HISTORIC AND DESIGN REVIEW COMMISSION

HDRC CASE NO: 2019-123
COMMON NAME: 131 N Mesquite ROW
ADDRESS: 133 N MESQUITE ST - ROW
LEGAL DESCRIPTION: NCB 590 BLK 3 LOT S 65.63 FT OF 20,21 AND ALLOF LOT C
ZONING: RM-4, UZROW, H
CITY COUNCIL DIST.: 2
DISTRICT: Dignowity Hill Historic District
APPLICANT: Kevin Bowyer
OWNER: City of San Antonio
TYPE OF WORK: Install new network node pole in right-of-way
APPLICATION RECEIVED: February 26, 2019
60-DAY REVIEW: April 26, 2019
CASE MANAGER: Huy Pham

The applicant is requesting a Certificate of Appropriateness for approval to install a new 37-foot wood pole to feature network node equipment at the right-of-way at 131 N Mesquite.

Proposed

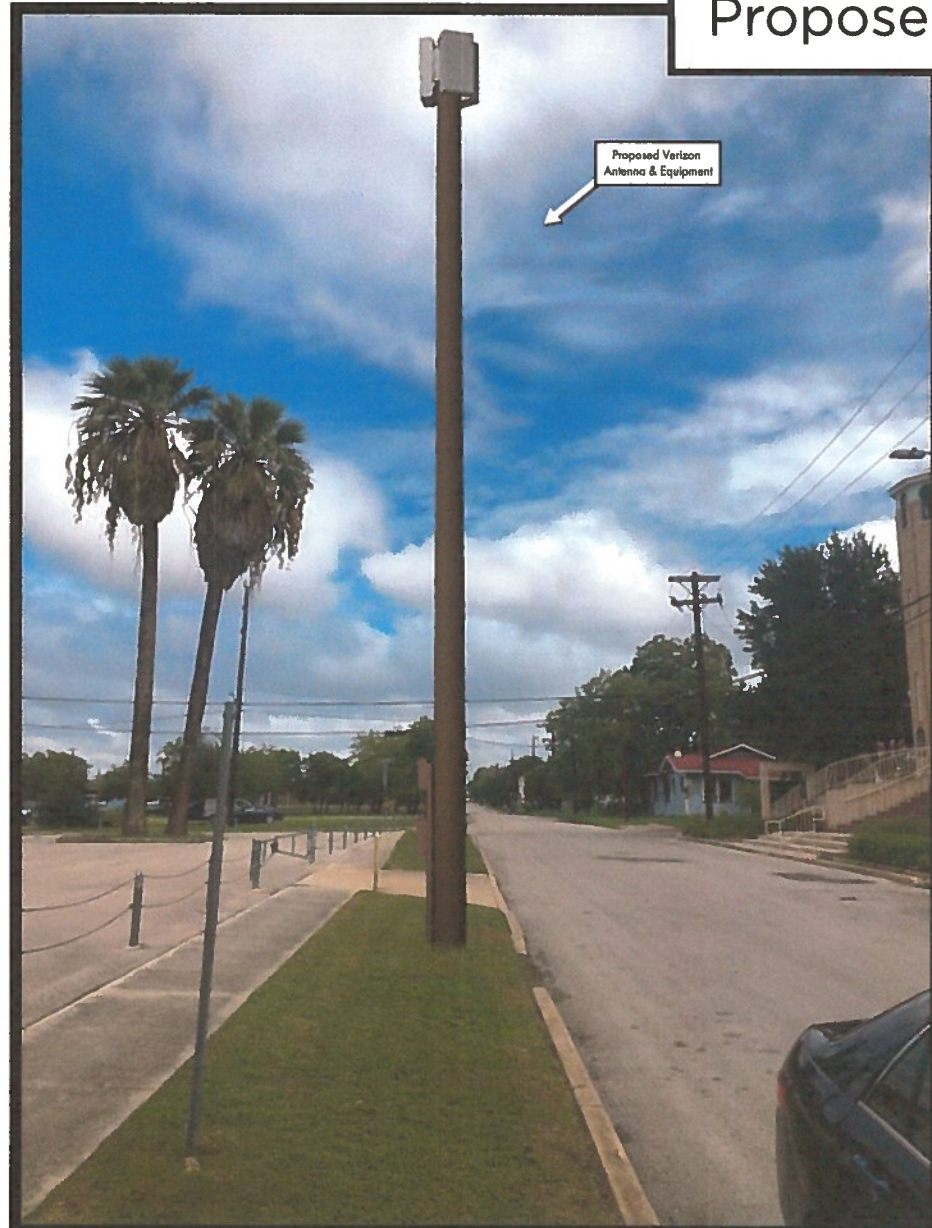
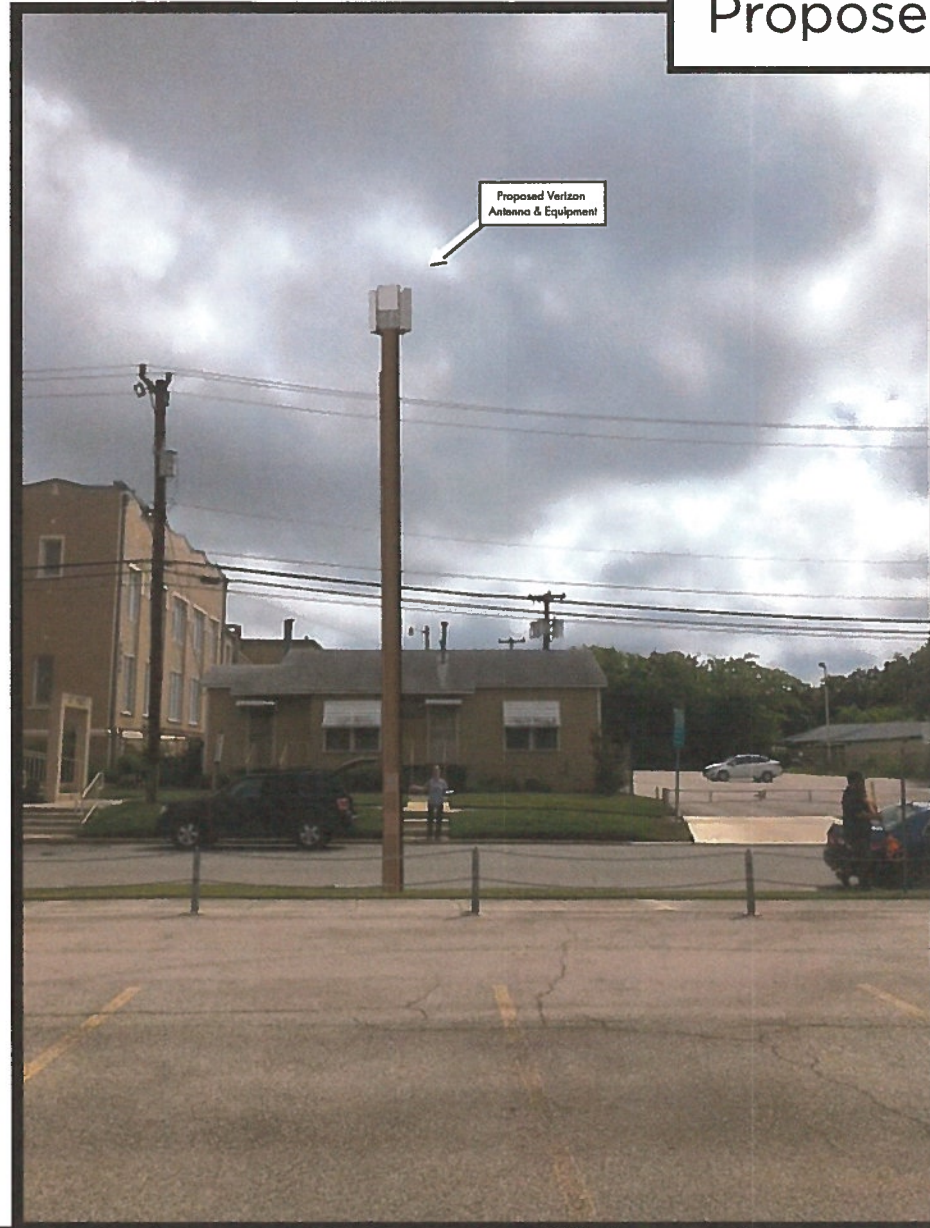
- b. LOCATION - The applicant has proposed to install a new wood pole featuring network node equipment at the right-of-way at 131 N Mesquite, between cross streets Center to the north and E Commerce to the south, at the approximate coordinates [29.422064, -98.474807]. The proposed location is mid-block, directly across to the street to a contributing one-story structure at 124/130 N Mesquite and diagonal to Brackenridge School historic site. Per the Design Manual 3.B.i., new poles must be generally located at commercial corners and intersections. Staff finds that the mid-block location that bisects the view of the 124 N Mesquite is inappropriate.

- e. HEIGHT – The applicant has proposed to install a wood pole with a height of 35 feet (35') with equipment extending a total of 37 feet (37') from grade. Per the Design Manual 3.B.iv., the height of new node support poles should not exceed the established predominant height of other poles and historic site elements located within 500 feet of the proposed installation. Staff finds that the proposed height is subordinate to existing poles within the proximity.

- g. DESIGN – The applicant has proposed to install a wood pole with a meter socket (box), service disconnect (box) and linear conduit up to six feet (6') and three (3) au/rap units (grey cabinets) that are 11.4 inch wide, 14.6 inch

tall, and extend no more than one foot (1') from the wood pole. The applicant referenced existing wood utility poles in selecting the pole type in this location. Per the Design Manual 3.B.: *The Historic Preservation Officer may require concealment of the support pole in the form of aesthetically appropriate street lamps, site elements, district signage, or other stealth methods. The color of any new support pole or concealment solution shall be determined by the Historic Preservation Officer based on site specific conditions.* Staff finds that no efforts have been made to conceal or relate the proposed new pole to the existing context or site elements at N Mesquite – except the use of a wood pole.

Staff does not recommend approval of the new network pole based on findings b through g. While approval may still be issued at the commission's discretion, the following requirements have not been met per the Right-of-way Network Node Design Manual:

- i. COLLOCATION - Documented efforts to explore a nearby collocation have not been submitted.
- ii. LOCATION – The proposed pole is not located at a commercial corner or intersection.
- iii. SEPARATION – The proposed pole is not separated from existing poles by more than 250 feet.
- iv. DIAMETER – The proposed pole is not less than 8 inches at its widest portion.

SITE PLAN

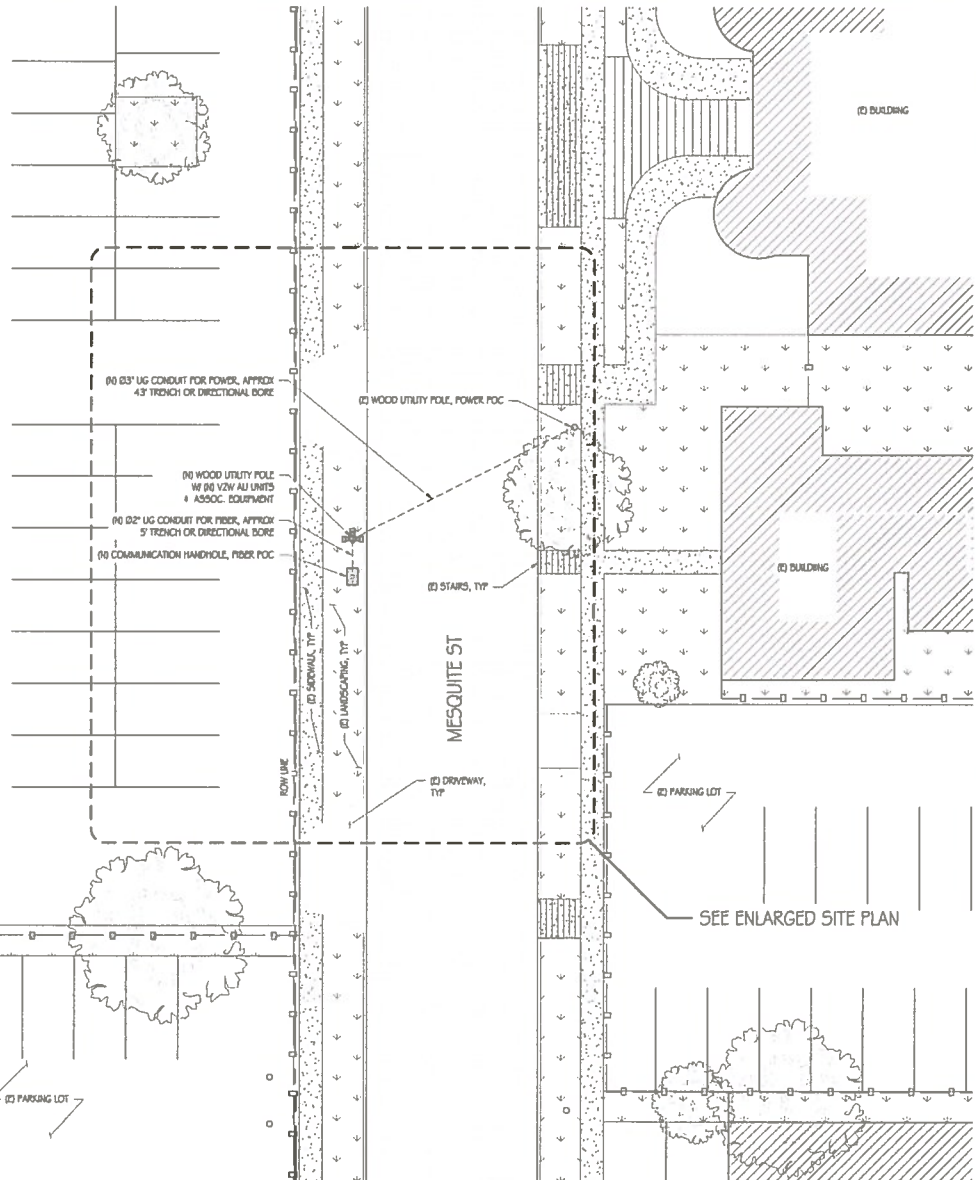
- c. SEPARATION – The applicant has proposed to install the new pole within the immediate block as four existing utility poles. Per the Design Manual 3.B.ii., new poles must be separated from existing poles by 250 feet. Staff finds that the proposed location is not separated by more than 250 feet.

ELEVATIONS

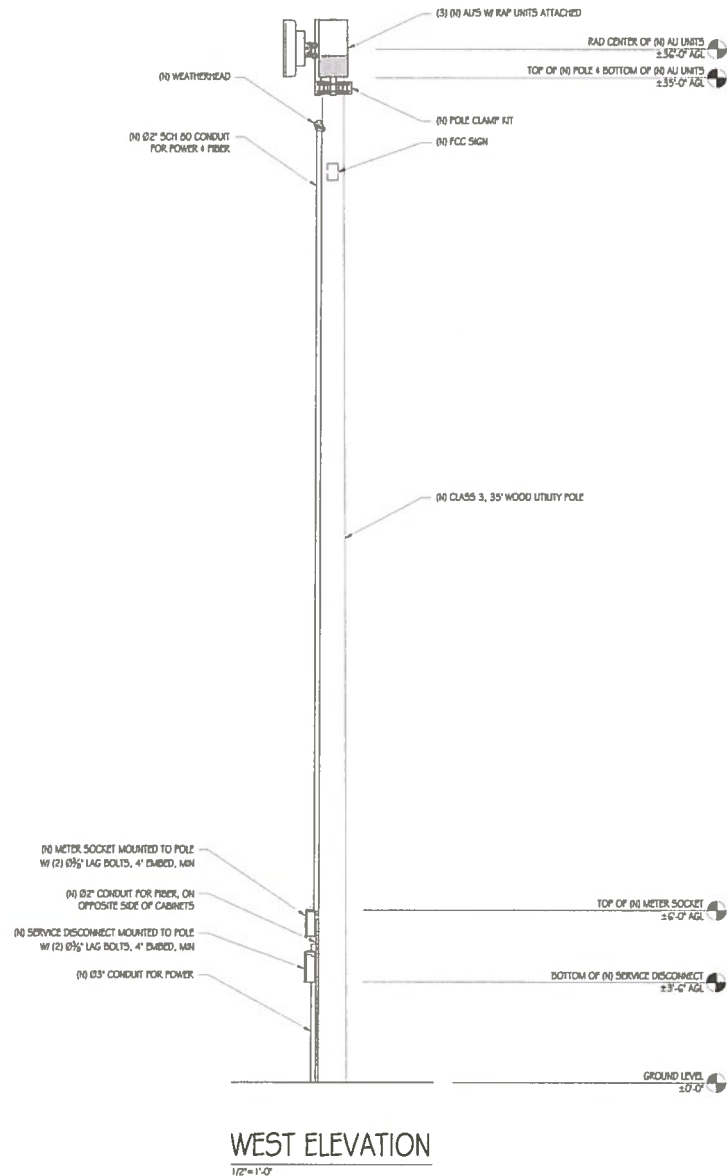
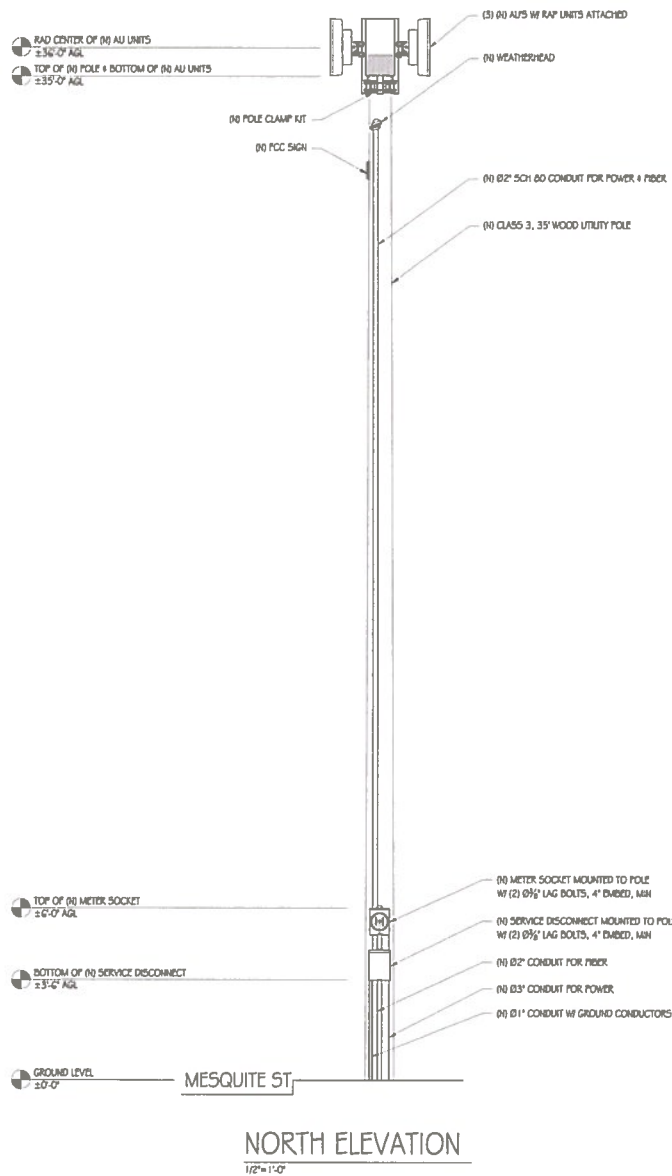
- f. DIAMETER – The applicant has proposed to install a pole that is 32 inches (32") in diameter excluding the meter boxes at the pedestrian level and the antenna cabinets at the top. Per the Design Manual 3.B.v., new poles should not exceed 8 inches (8") in diameter at the widest portion of the pole. Staff finds that the proposed pole diameter is four times wider allowed by the design manual.
